Modern robotics device detection problems

Peter Brier

FTC Brabant

February 2016

5V and RESET voltage measurement on PIC

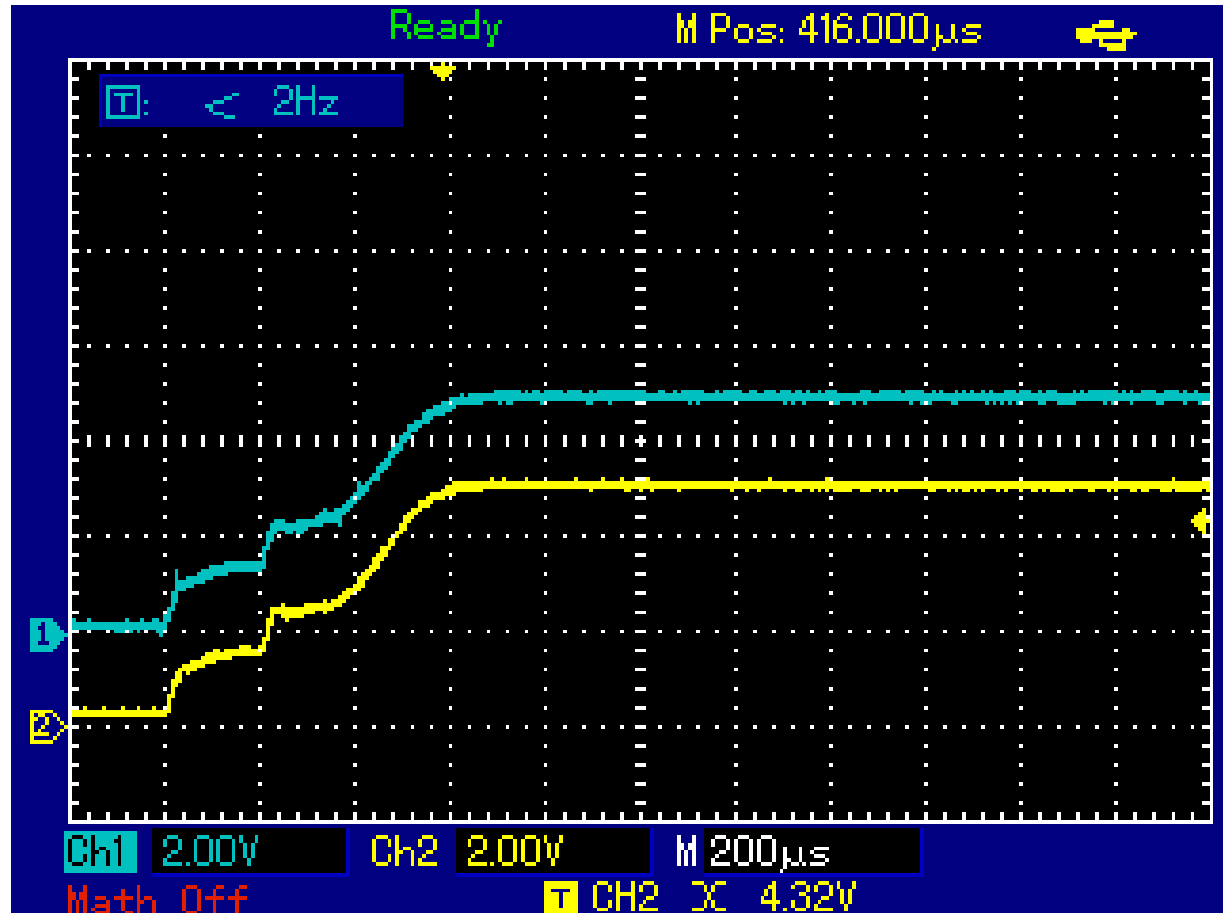
CH1 (Yellow) = 5V
CH2 (blue) = RESET

No delay in reset line!
Reset connected to 5V via $R=100\text{k}\Omega$
No capacitor on reset line

(datasheet suggests $500\text{ }\Omega < R < 10\text{k}\Omega$)

Is the 64msec power up reset timer active?
If not: can cause problems at reset!

Actual circuit used in Core Module
R=100kOhm

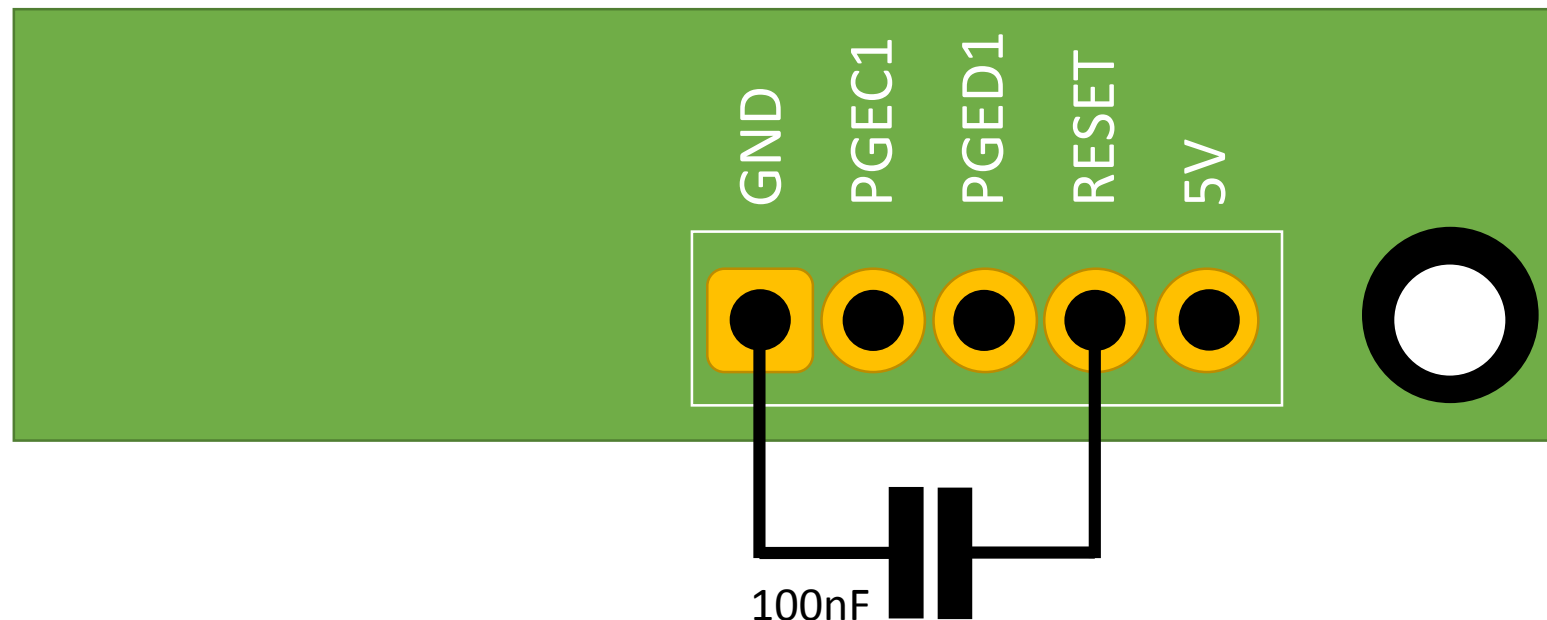
(docs suggest: R=500..10k)
